MEADOWBROOK PARK PLANNED UNIT DEVELOPMENT (PUD) PLAN

PROJECT NO. 096956009
SHEET

PUDSP Redlines V_1.pdf Markup Summary 12-15-2020

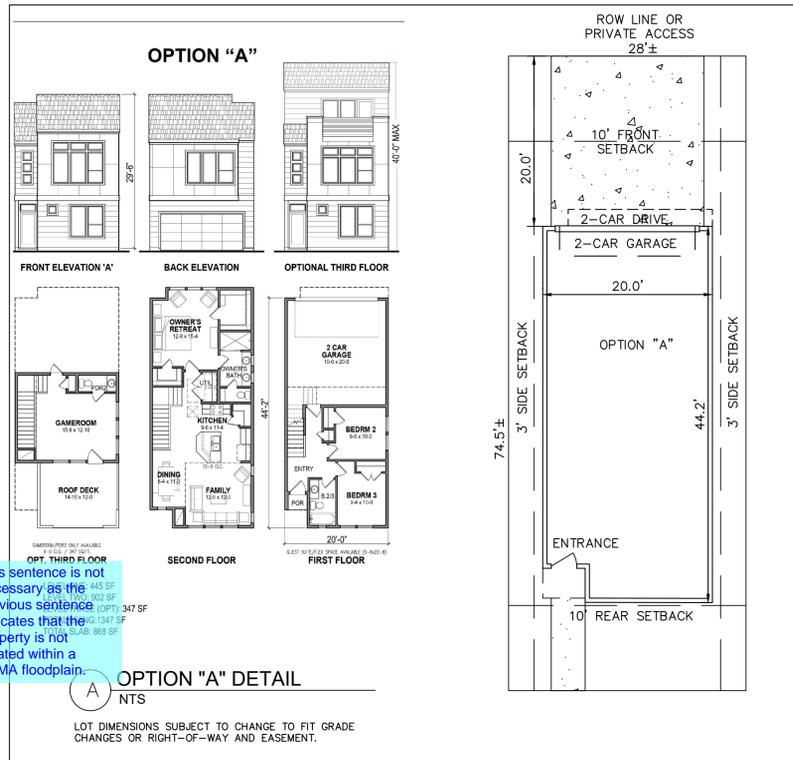
What is this column?

this column seems off, you say 40 spaces provided here and column over you say 80

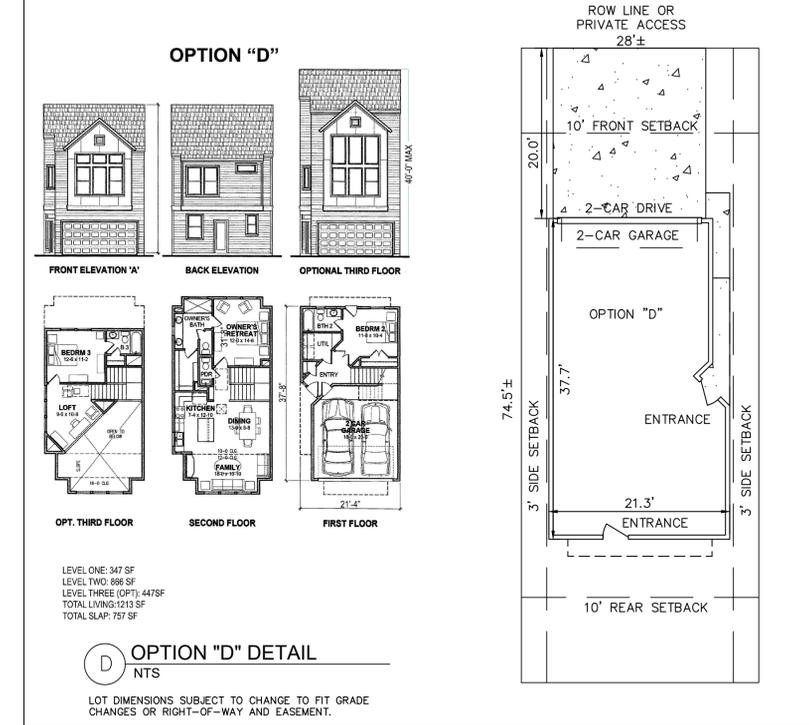
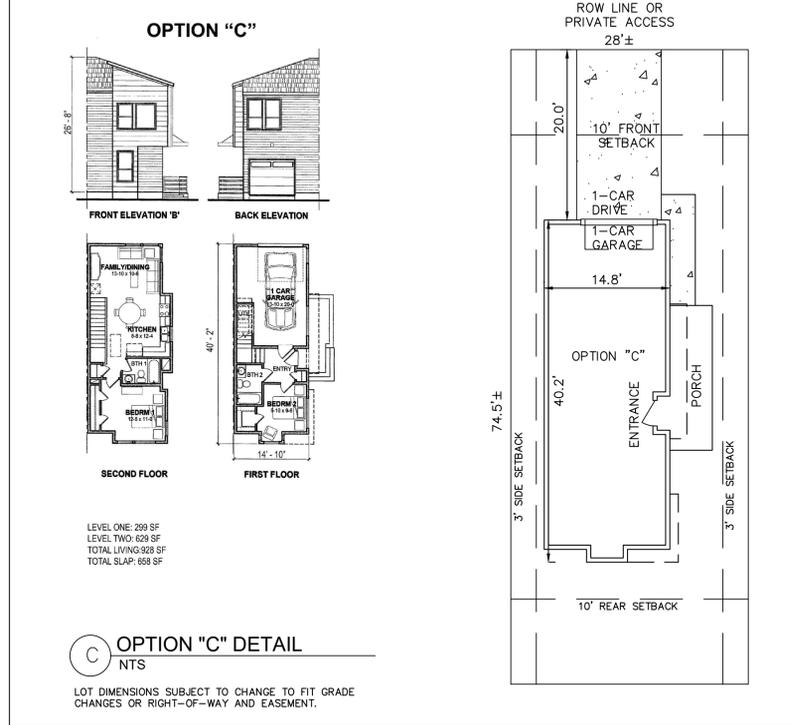
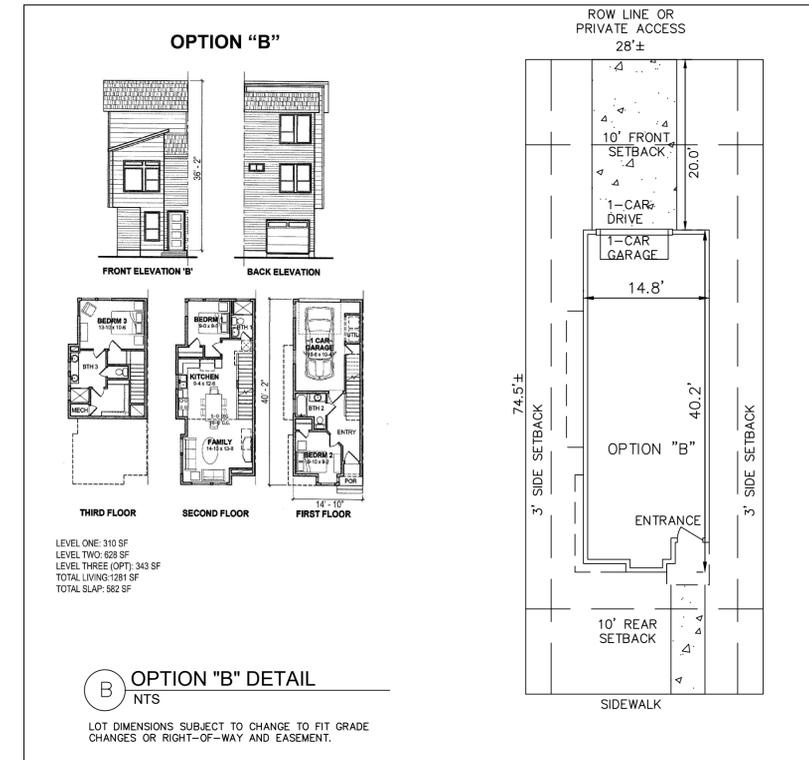
private roads will be access permit waiver

this may not be ok if developer is constructing private roads and utilities are in, it may be better for developer to install, space is tight...

This sentence is not necessary as the previous sentence indicates that the property is not located within a FEMA floodplain.

don't repeat content provided elsewhere-its not necessary...example fencing,
This note is confusing? Are you building public streets?

PROJECT NO.
096956009
SHEET
05 OF 11

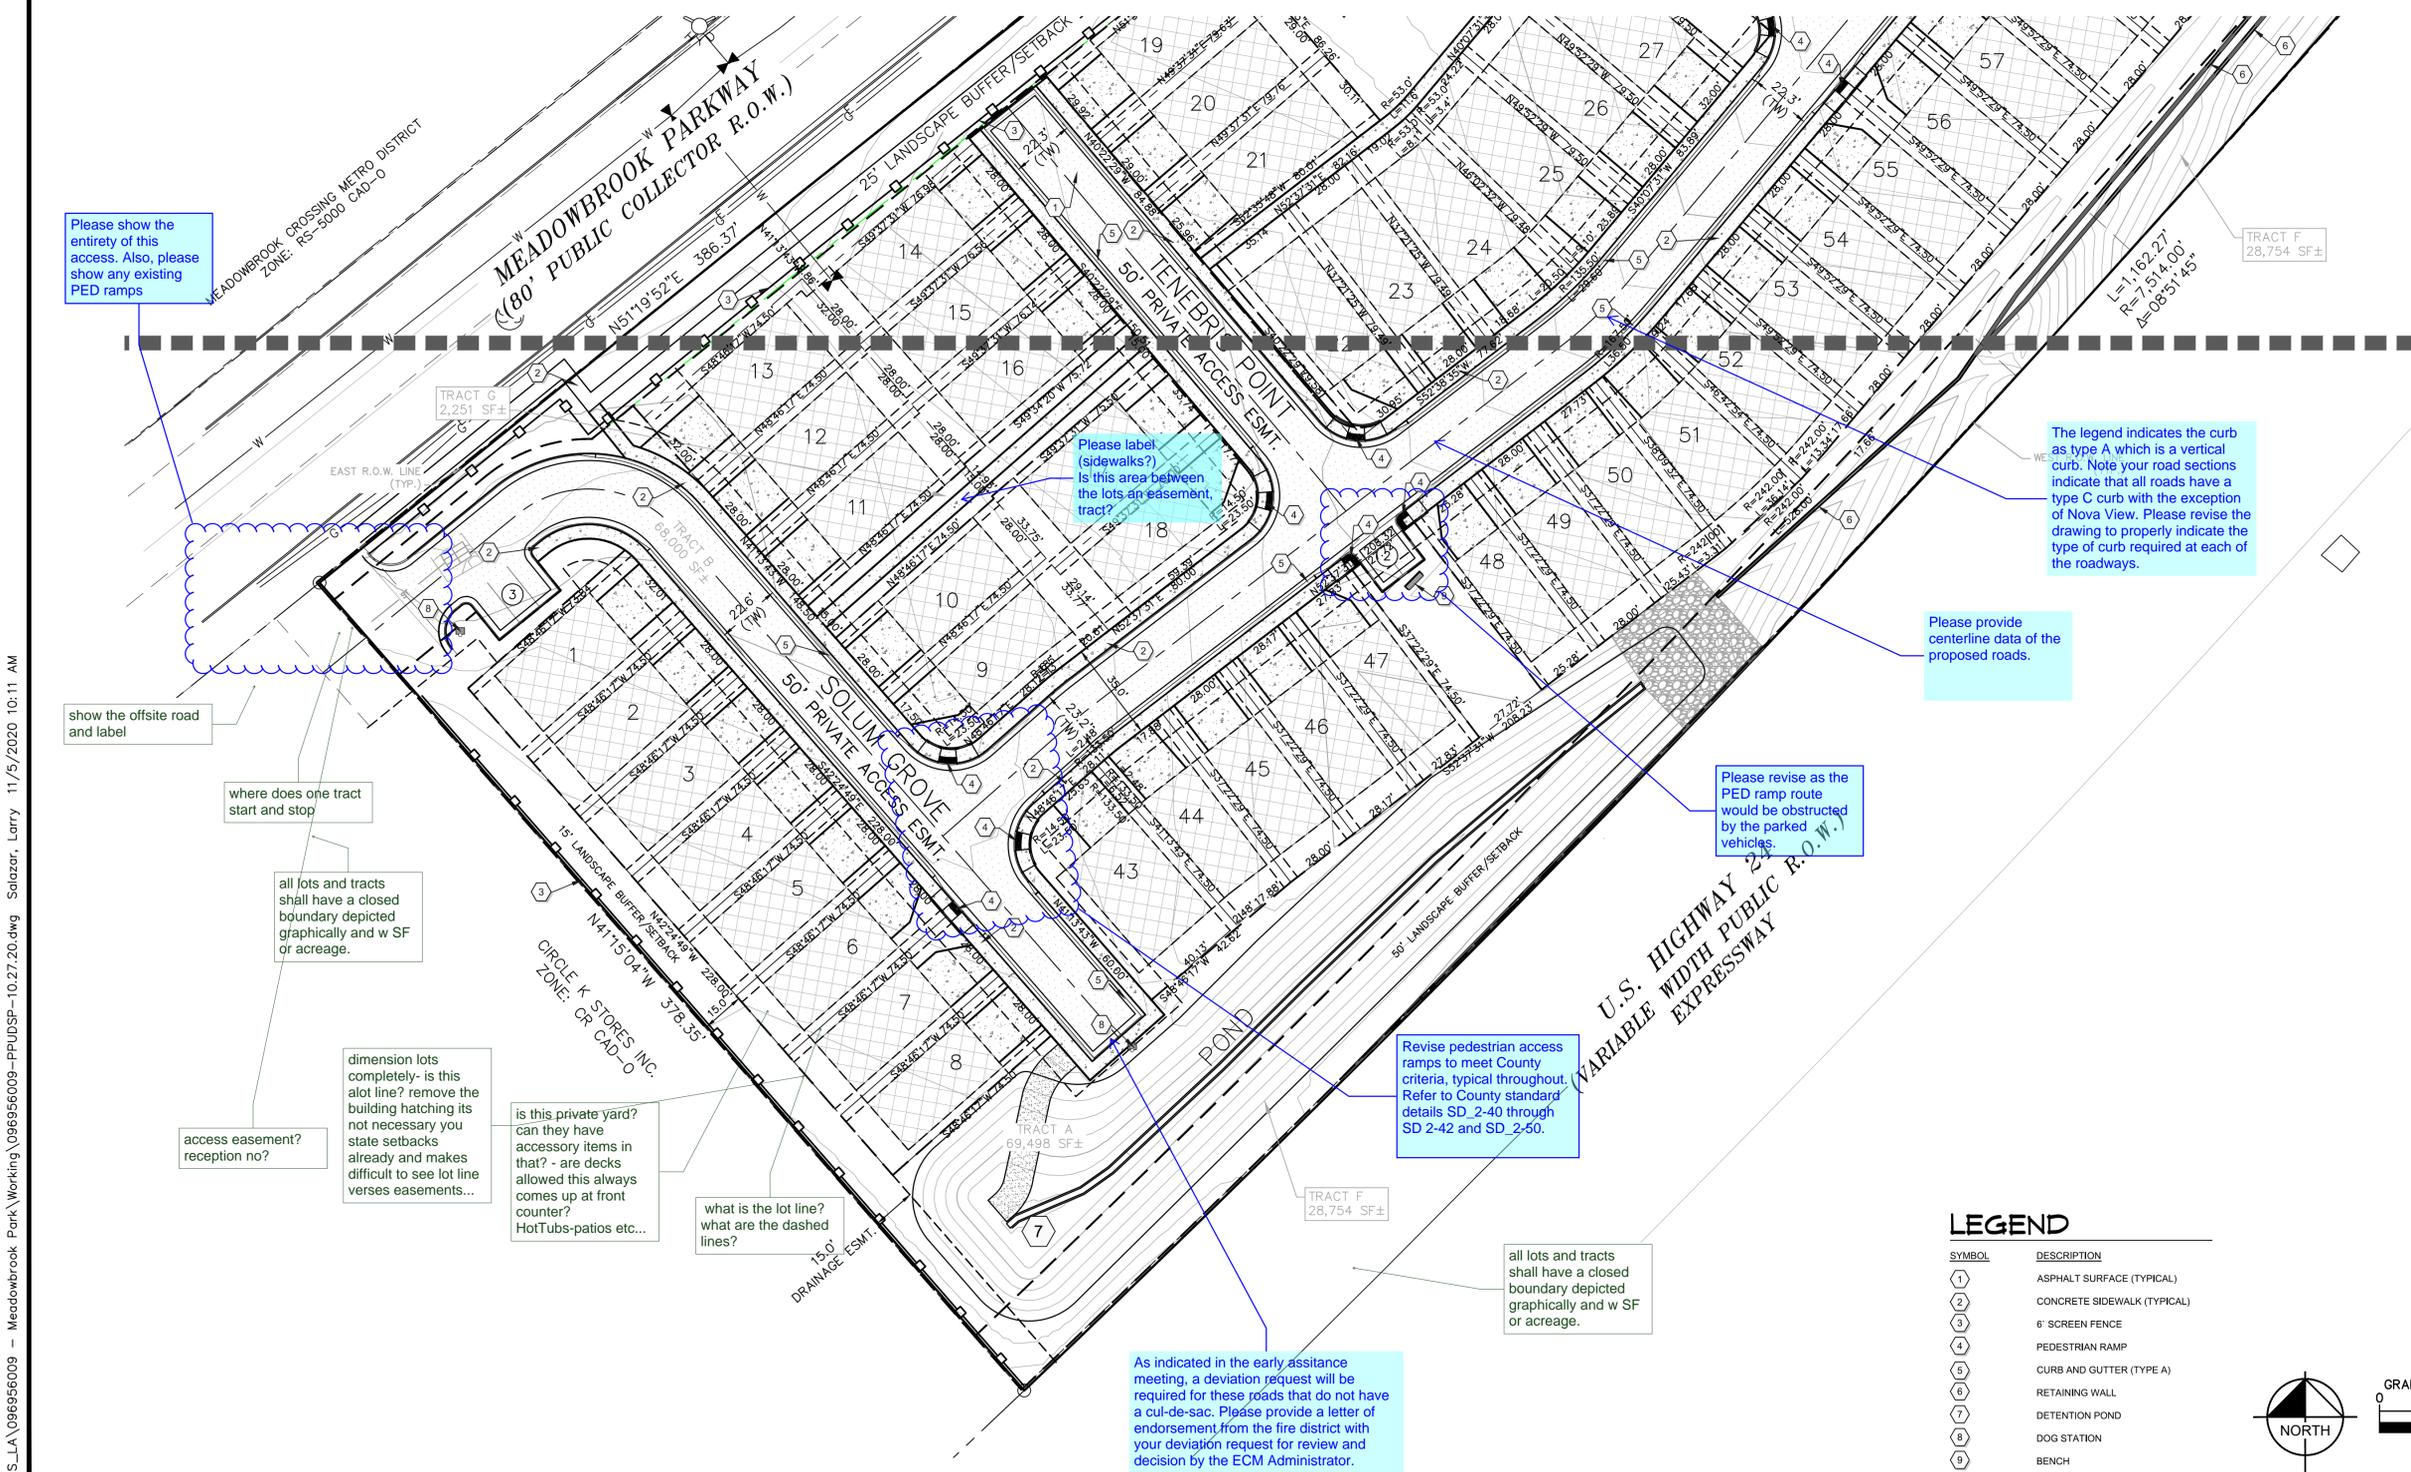
Please show the entirety of this access. Also, please show any existing PED ramps

Please label (sidewalks?) Is this area between the lots an easement, tract?

The legend indicates the curb as type A which is a vertical curb. Note your road sections indicate that all roads have a type C curb with the exception of Nova View. Please revise the drawing to properly indicate the type of curb required at each of the roadways.

Please provide centerline data of the proposed roads.

Please revise as the PED ramp route would be obstructed by the parked vehicles.

Revise pedestrian access ramps to meet County criteria, typical throughout. Refer to County standard details SD 2-42 and SD 2-50.

As indicated in the early assistance meeting, a deviation request will be required for these roads that do not have a cul-de-sac. Please provide a letter of endorsement from the fire district with your deviation request for review and decision by the ECM Administrator.

show the offsite road and label

where does one tract start and stop

all lots and tracts shall have a closed boundary depicted graphically and w SF or acreage.

access easement? reception no?

dimension lots completely- is this alot line? remove the building hatching its not necessary you state setbacks already and makes difficult to see lot line verses easements...

is this private yard? can they have accessory items in that? - are decks allowed this always comes up at front counter? HotTubs-patios etc...

what is the lot line? what are the dashed lines?

all lots and tracts shall have a closed boundary depicted graphically and w SF or acreage.

PRELIMINARY LANDSCAPE PLAN MEADOWBROOK PARK RESIDENTIAL LAYOUT

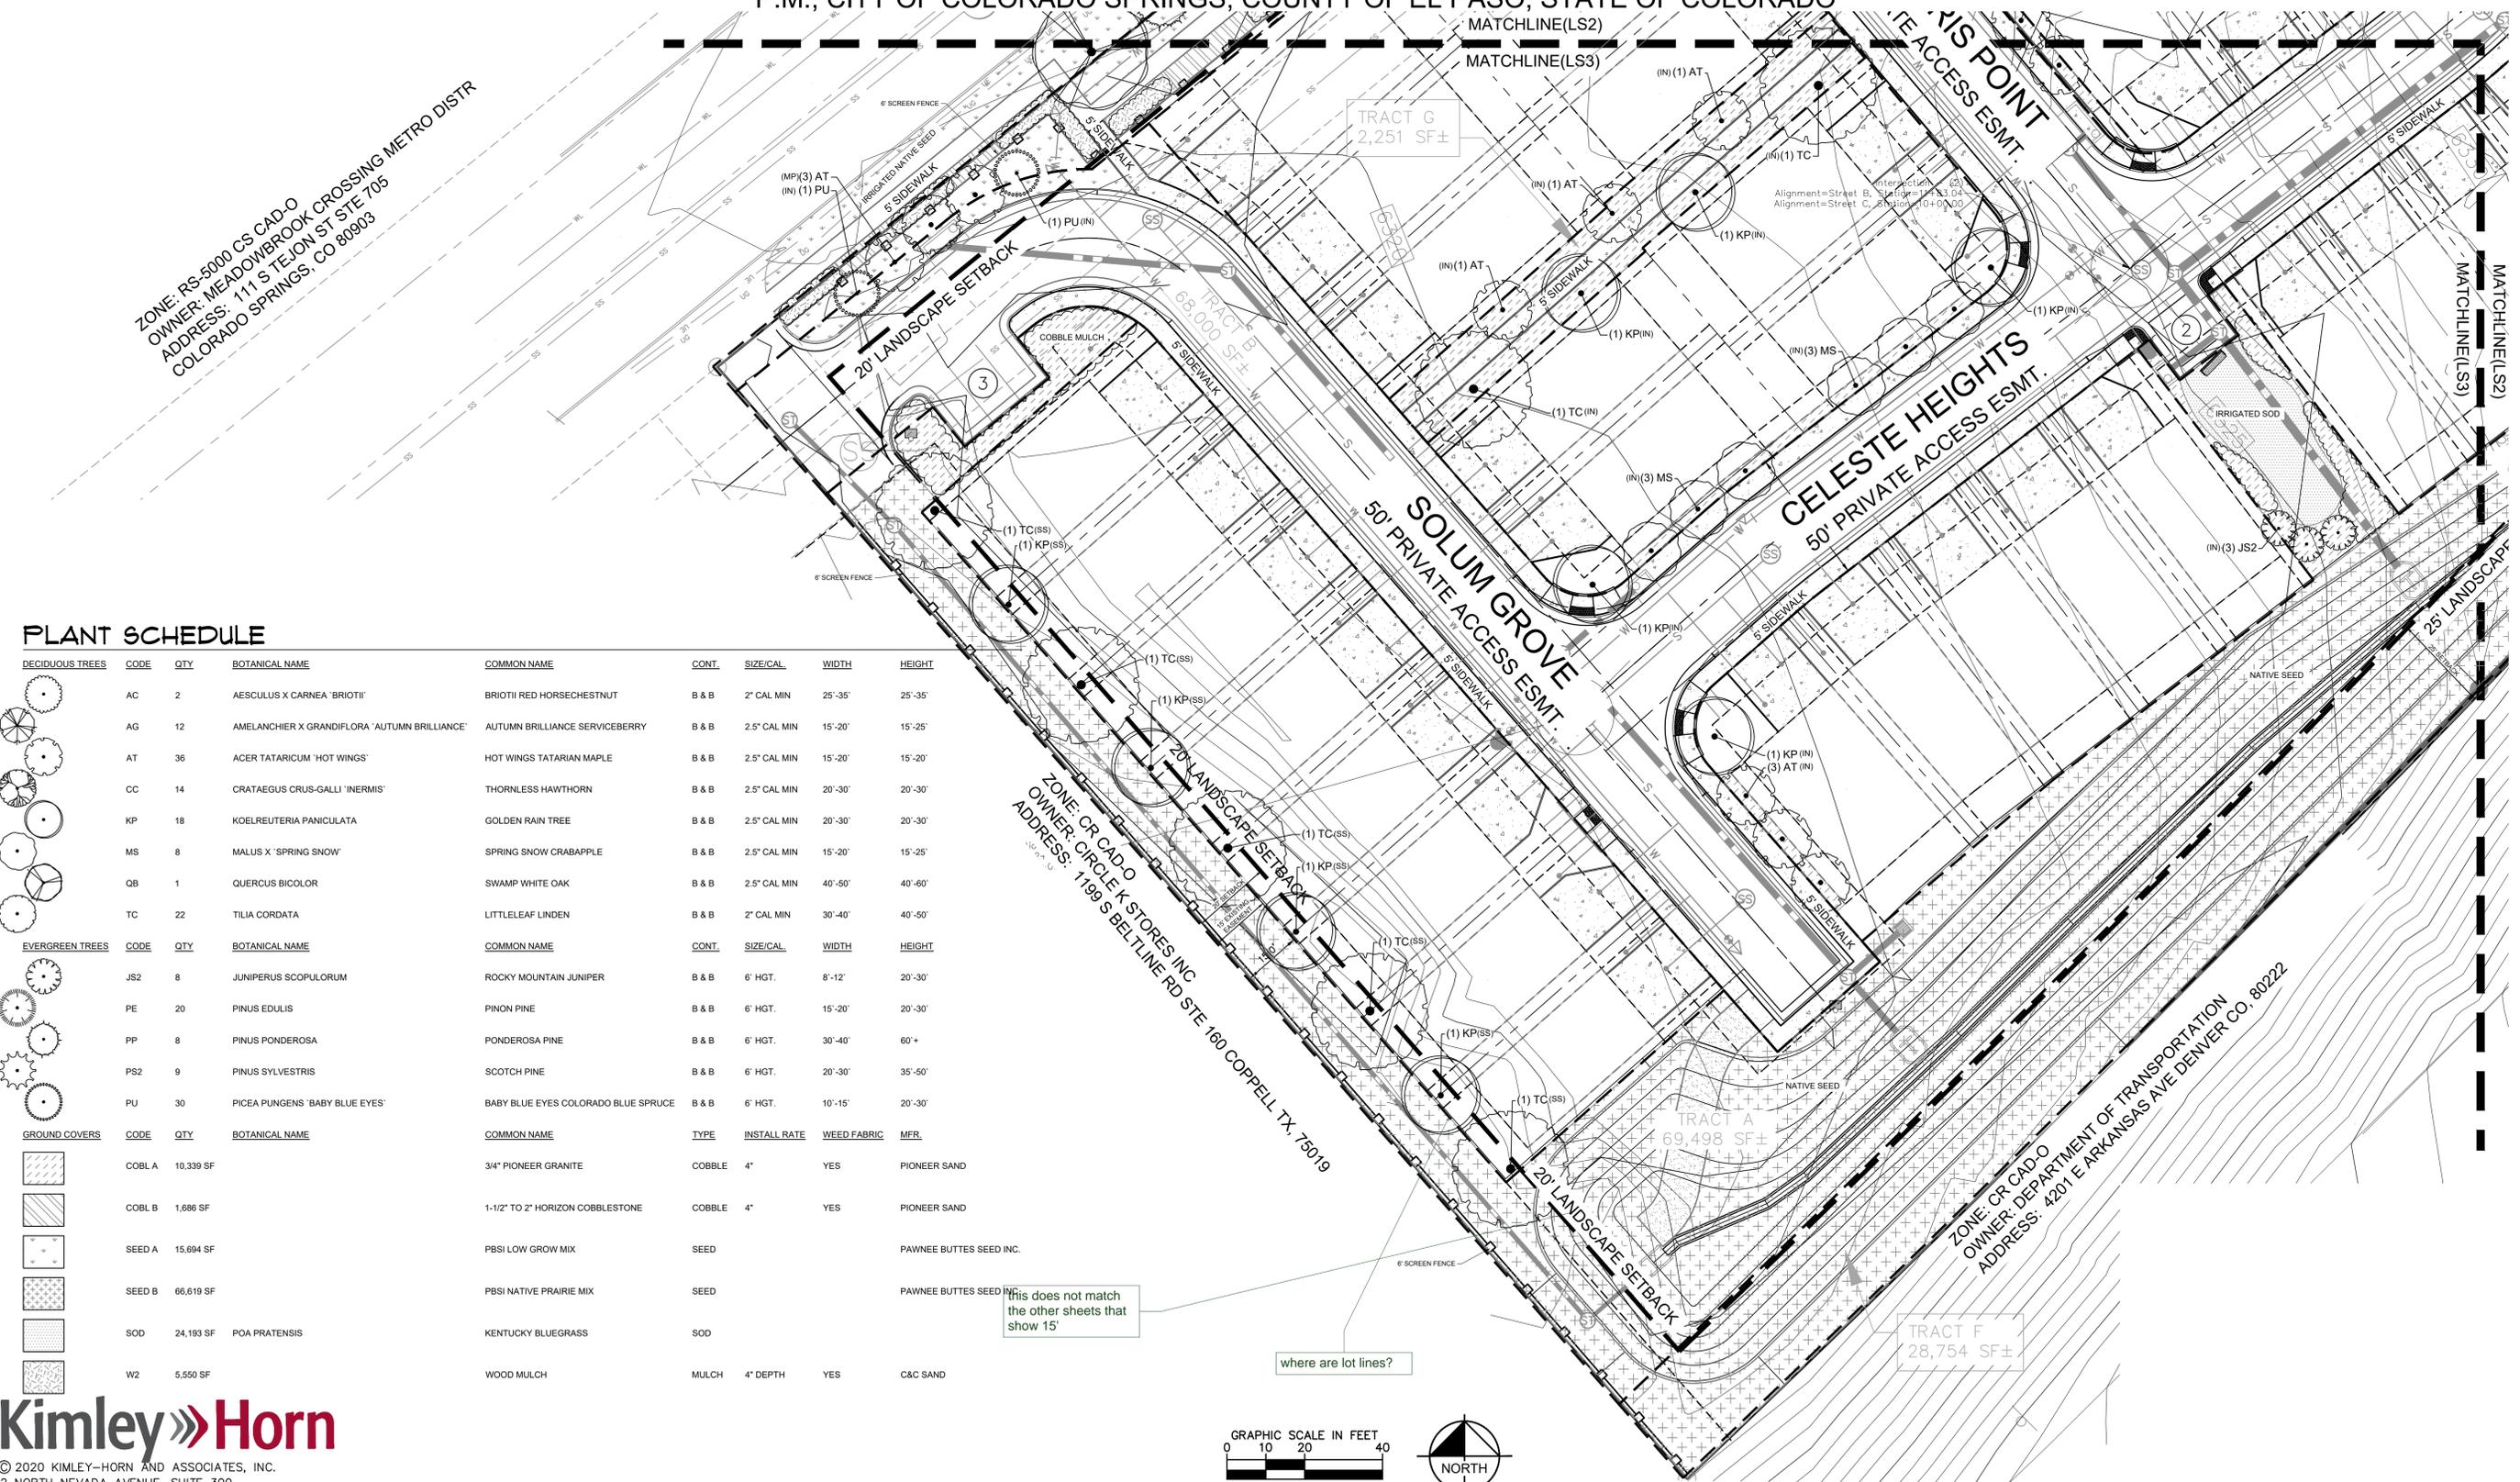
This does not match the other sheets that show 15'

where are lot lines?
